CPP Project 7282

Subject: Wind Engineering – Lend Lease Circular Quay

Please find herein comments regarding the impact of changes to the tower and podium envelopes on the pedestrian level wind conditions at the Lend Lease Circular Quay development (LLCQ).

Figure 1: Elevation drawing of LLCQ podium (Hassell 005567-61A-P)

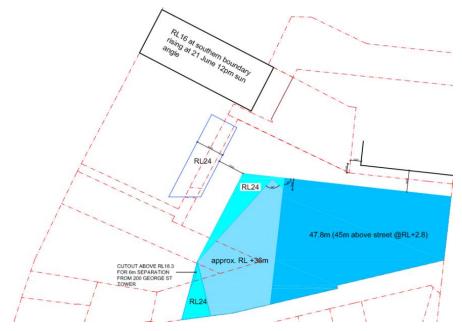
The Hassell drawings provided by Lend Lease, Figure 1 and 2, have been reviewed and assessed from an environmental wind perspective at ground level. Compared with the massing model used for the wind tunnel testing of LLCQ, Figure 3 and 4, the architectural form of the building has been developed, but the general massing of the building has remained similar. The maximum height of the tower has been increased by 48 m to rise 248 m above Underwood Street. The setback on Pitt Street remains and pedestrian level winds along Pitt Street are expected to remain within the Business walking category of the Lawson criterion.

Figure 2: Elevation drawing of tower envelope refinements (Hassell 005567-61A-P)

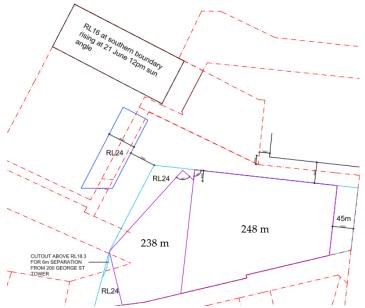
The minimum distance to the 200 George Street development façade has been increased to 6 metres and the LLCQ façade in this area has been pulled back from the adjacent façade. This has been achieved by both moving the LLCQ façade eastwards and reducing the angle of the western corner. The podium geometry in this area is relatively unchanged, and conditions in the north-south laneway to the plaza are not expected to change significantly. The reduction in size of the structure on the west side of the plaza may improve conditions slightly in the northsouth laneway to the detriment of conditions in the plaza.

Figure 3: CPP Wind tunnel model of original LLCQ model, view from north-west

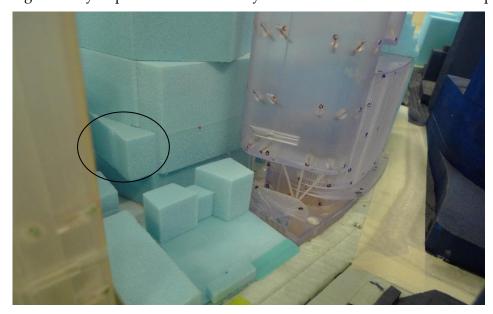
Although the triangular overhang on the north-west corner of the podium has been removed (circled in Figure 3) and the plaza massing has been altered slightly, these modifications are not expected to significantly impact the wind amenity of both the east-west link and the plaza.
